Reply to the referee comments

Julia Steiner

1 Referee 1

Figure 4. Coarsest considered mesh for the ~~Agard~~ NHLP-90-L1T2 high lift configuration.

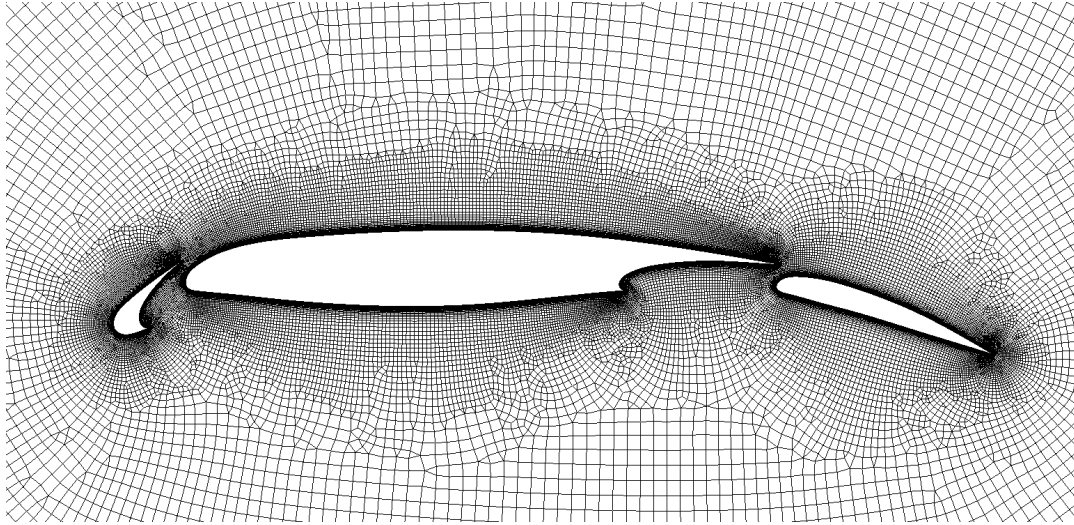
page 7, line 176: *Please refer to the airfoil correctly. The airfoil is called NHLP 90 L1T2 (see Woodward Lean, AGARD CP515) and it has been pub-*

lished by Moir as test case A2 for CFD validationdescribed in AGARD AR 303. The correction shall be propagated throughout the manuscript (e.g. page 8, line 201, caption of fig. 4 on page 9)
This has been corrected in the entire draft.

Figure 8. Pareto front example for the two-objective optimization with annotation of the two extreme and the intermediate objects. The color bars refers to the generation of the population.

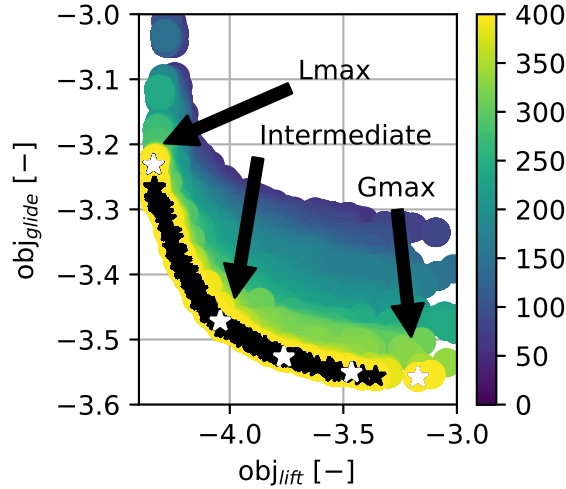
page 12, figure 8: This figure is a collection of all optimization data. It is not very explanative as it overlays too much information. It contains already data (of the integral design) that hasnt yet even been introduced and is decribed much later. This figure should be divided for the different design methods and commented accordingly in the text.

page 17, lines 367/369: This is a very late explanation for a figure that had been placed on page 12. It is necessary to split-up fig. 8 and to place the related illustrations close to the dicsussion in the text.
Again, splitting up the figure makes it more difficult to compare the trends. But as already mentioned we have added some clarification in the main text when the figure first appears.

Page 12, Figure 8: *What is Lmax, Interm and Gmax? What is the "integral design?*
The integral designs are obtained in an optimization procedure where both the slat and the main element are optimized simulataneously. A remark has been added in the text to say that the results of the integral design procedure are not relevant yet at this point in the text. Lmax, Interm and Gmax refer to the location of the designs on the pareto front as shown in the previous. This figure has been moved from the appendix to the main text, to make it more clear.

The figure contains a lot of information such that comparison between the different configurations and the different design procedures is possible. Hence, we propose to leave the figure as is. But we have added a note in the main text to clarify that some of the information in the figure will be discussed later on.

Figure 9. Slat characteristics from the auxiliary (−) and the integral (−.) design procedure in terms of **(a)** slat angle, **(b)** slat thickness, **(d)** slat camber, and **(d)** slat streamwise trailing edge location.

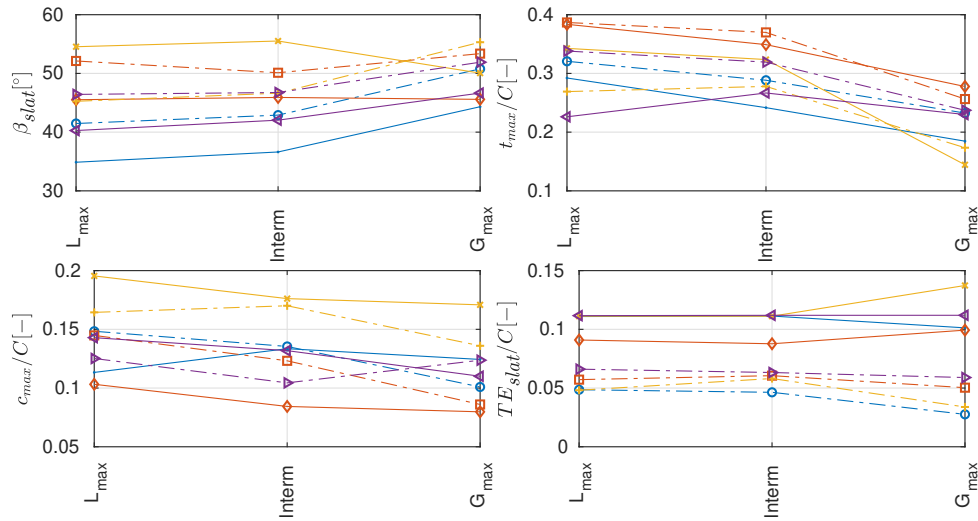
page 13, figure 9: *The line legend of figure 9 introduces an undescribed configuration A* in addition (same for fig. 14, and in figs 15-17 configs B*, C*, D*). The meaning and origin is perfectly unclear. It can only be assumed from later reading that this configuration related to the integral design that is described much later (starting from page 15). The pressure distributions shown in the right hand side are not discussed at all in the text.*
The legend text has been adjusted to include also the A* configuration.

Page 13: Figure 9: *Again, in the caption is stated "rough and "tripped without any further description.*
This has been explained in previous replies.
